Addendum #5

Bid Opportunity: CPS-RFT-25-03 - North Paris Fire Station

PROJECT: North Paris Fire Station

ADDENDUM 01

DRAWING NO.: M103

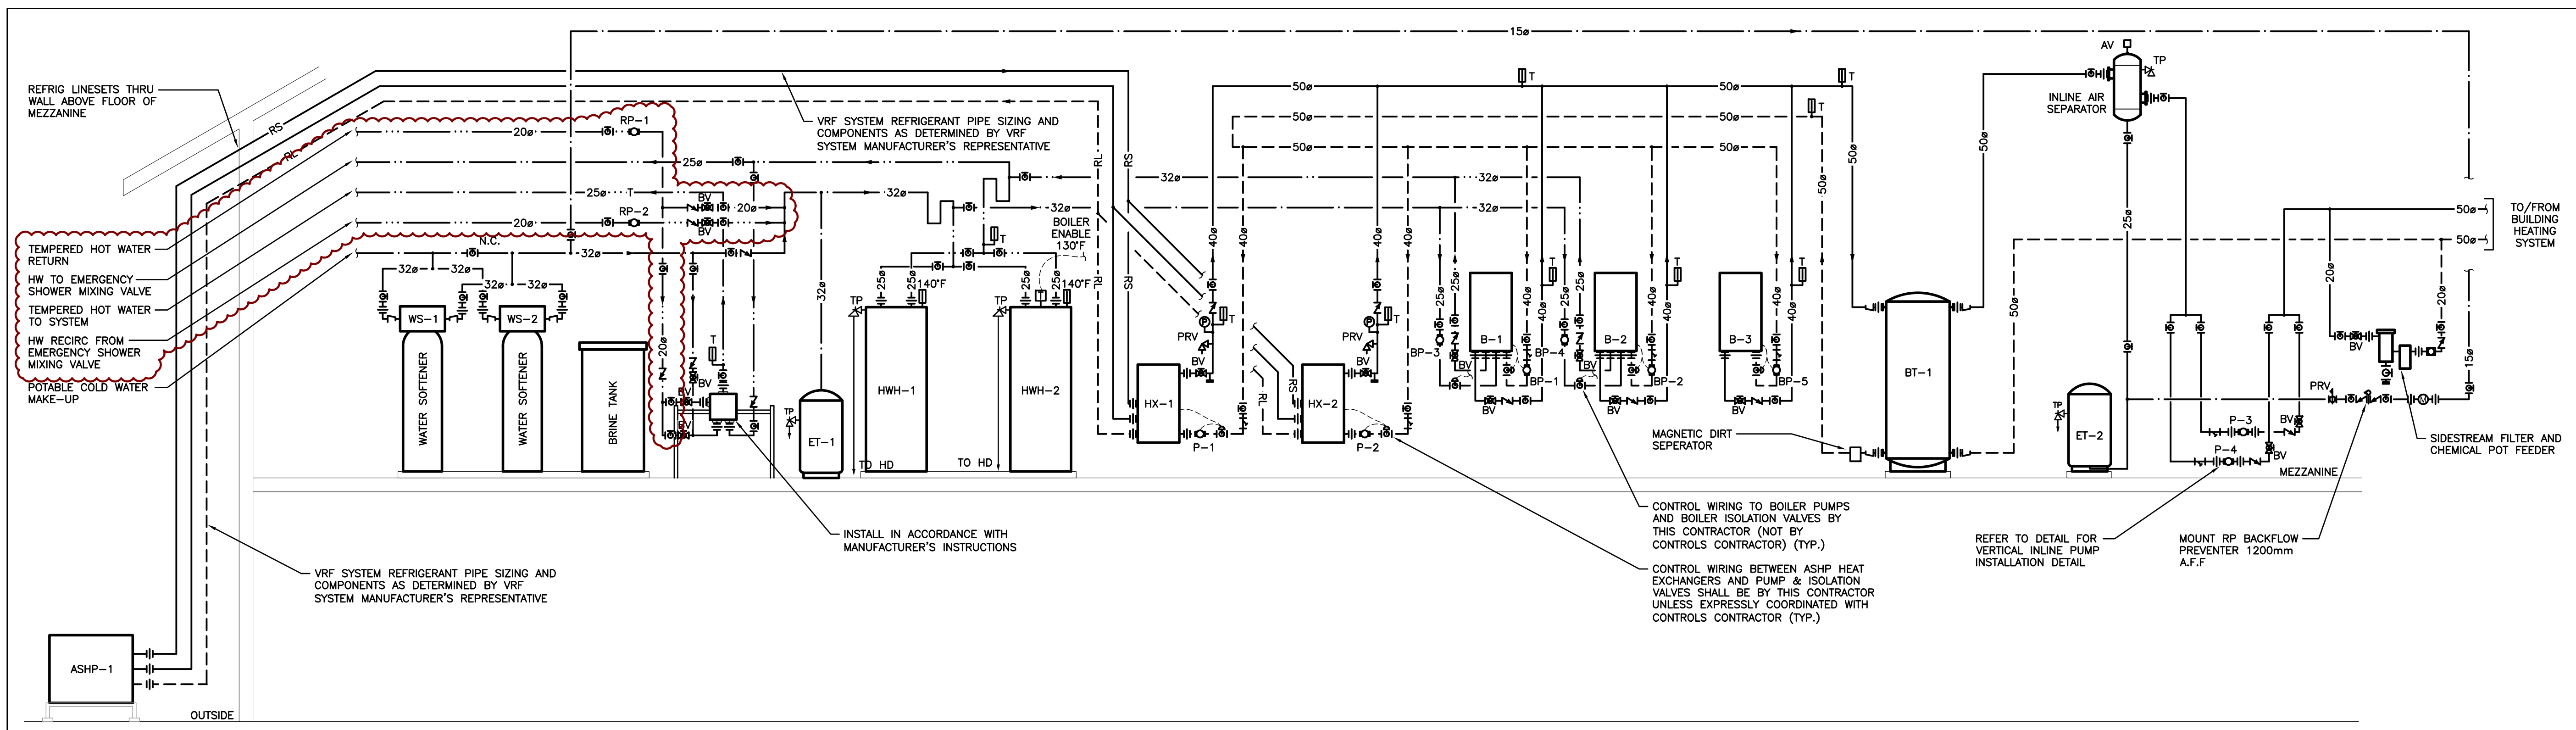
- 1.0 Reference Attached Reissued Drawings M103, M401, and M402
 - .1 Provide new hot water recirculation pipe to serve emergency shower mixing valve, complete with hot water recirculation pump RP-2. Separate hot water recirculation pipe serving the rest of the building to connect prior to thermostatic mixing valve only.

E105

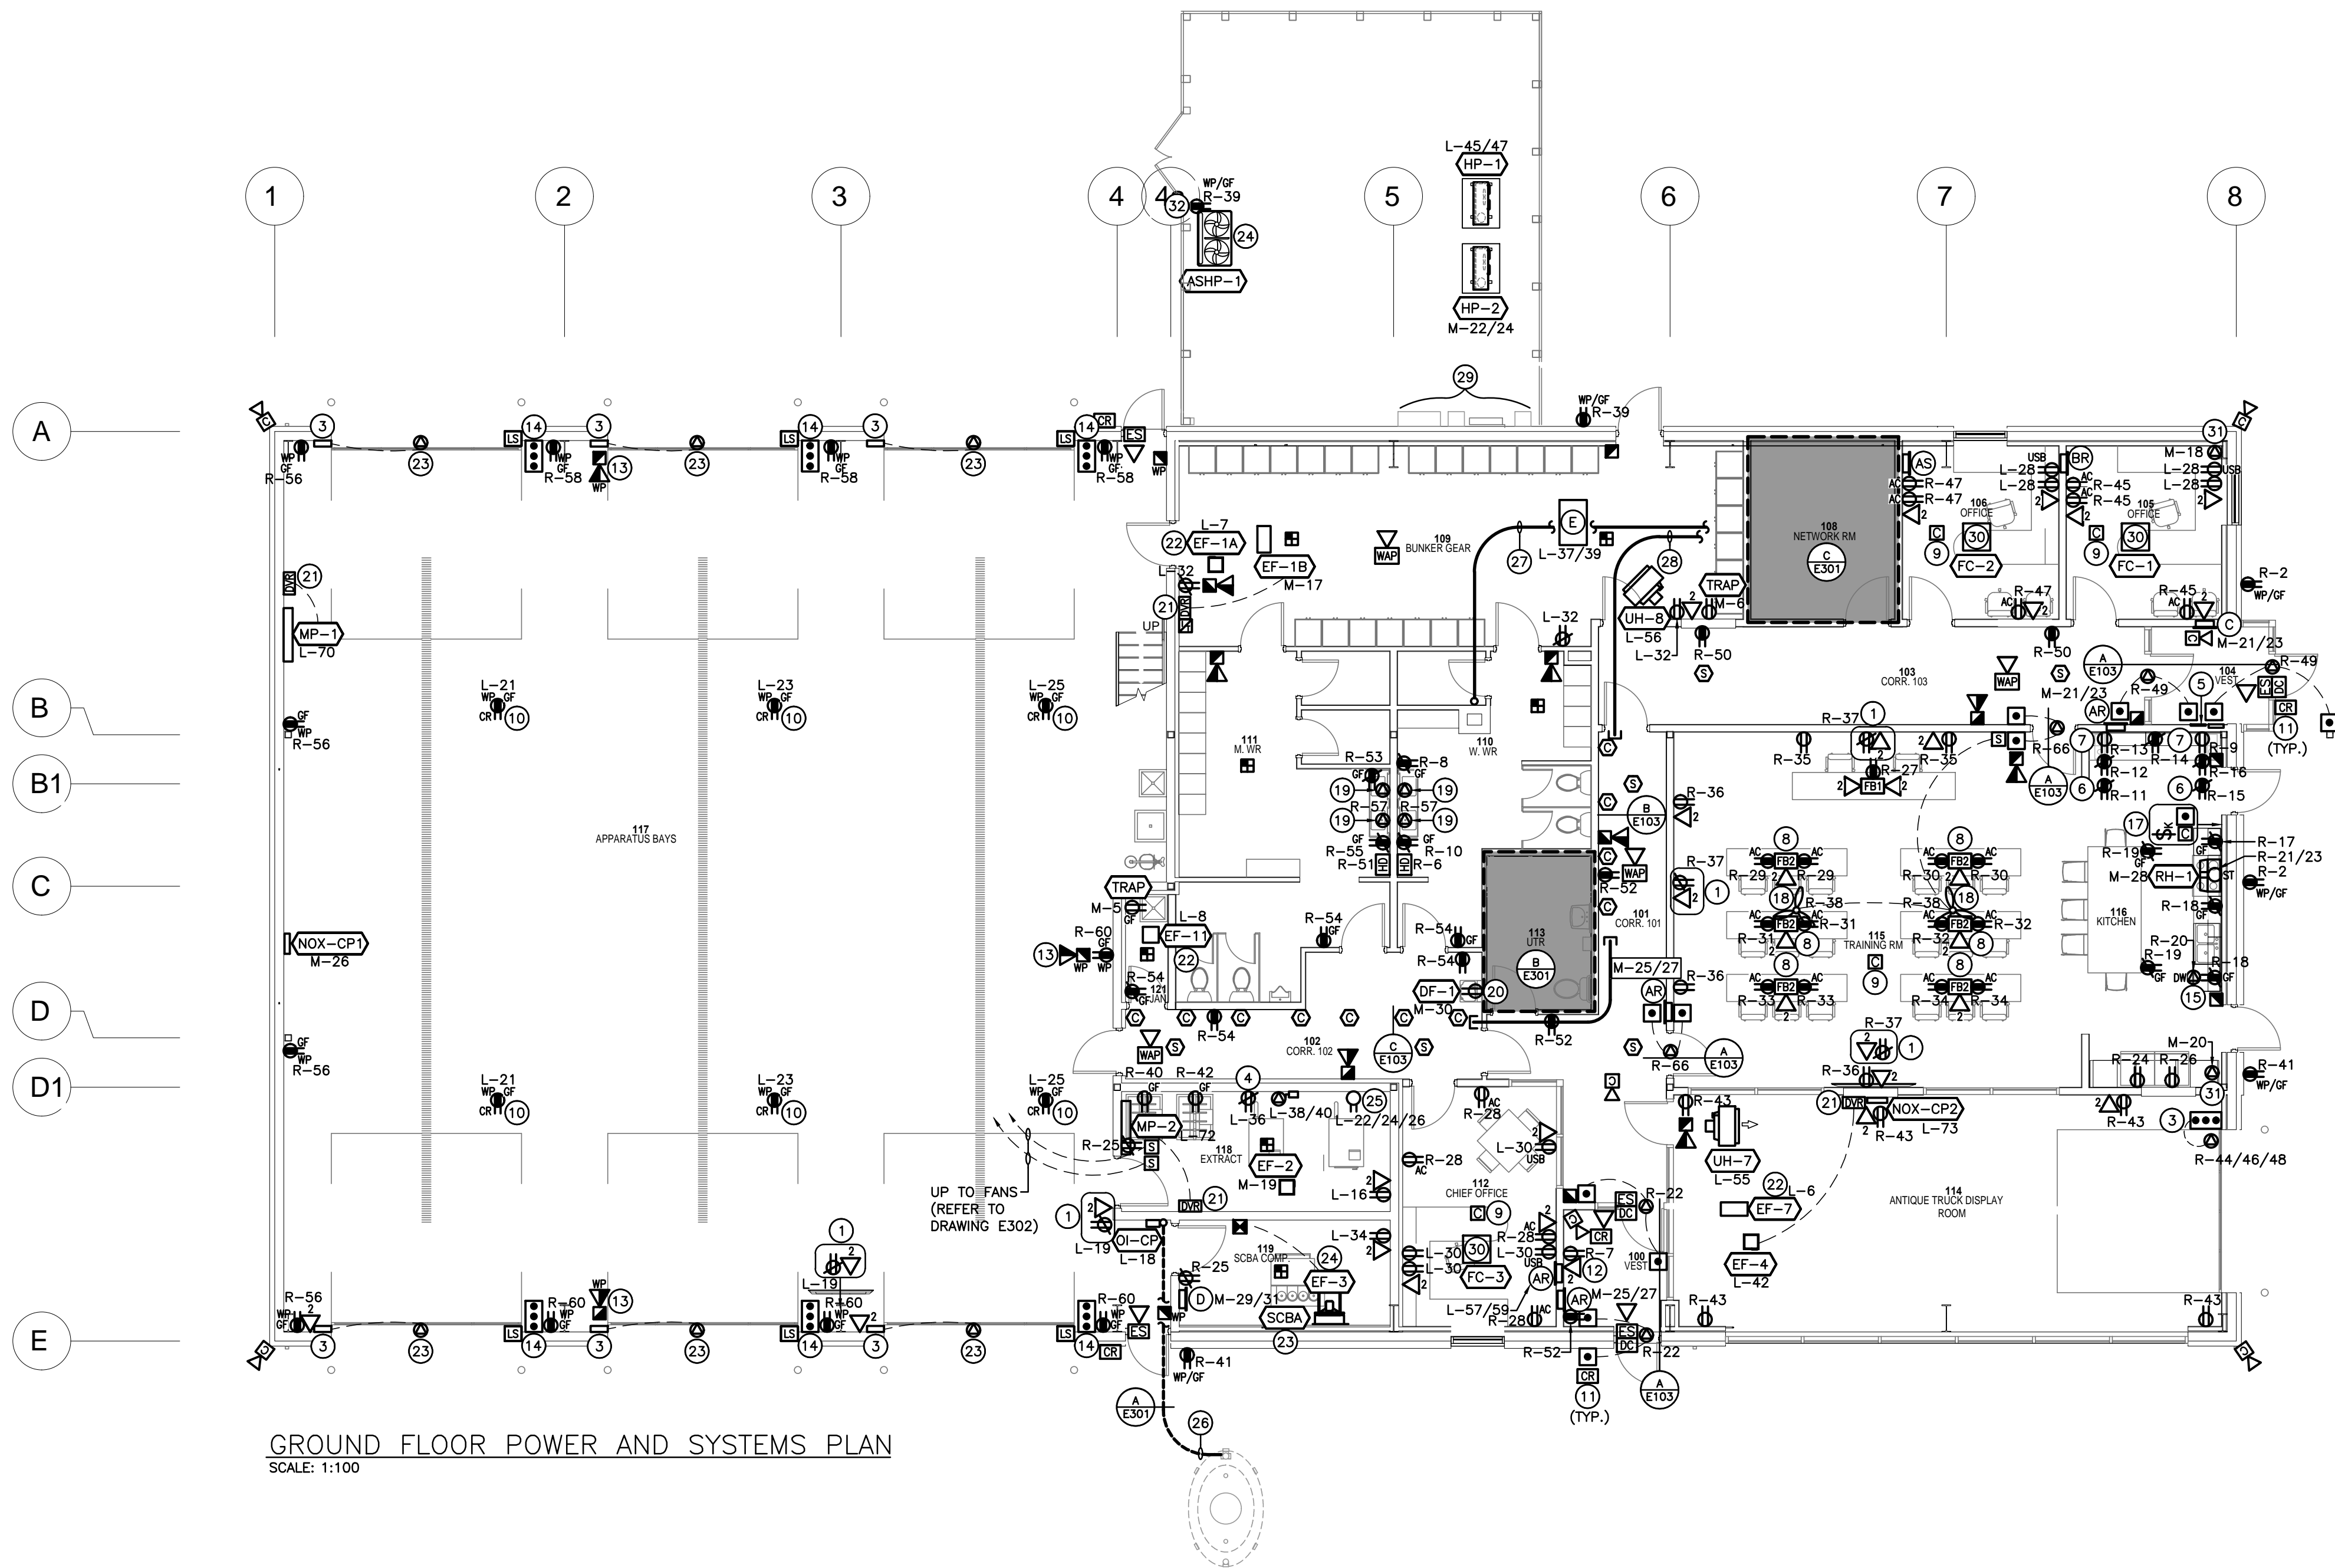
- 3.0 Reference Attached Reissued Drawing E105
 - .1 In the equipment wiring schedule, domestic recirculation pump (RP-2) added to schedule as indicated on attached reissued drawing E105.
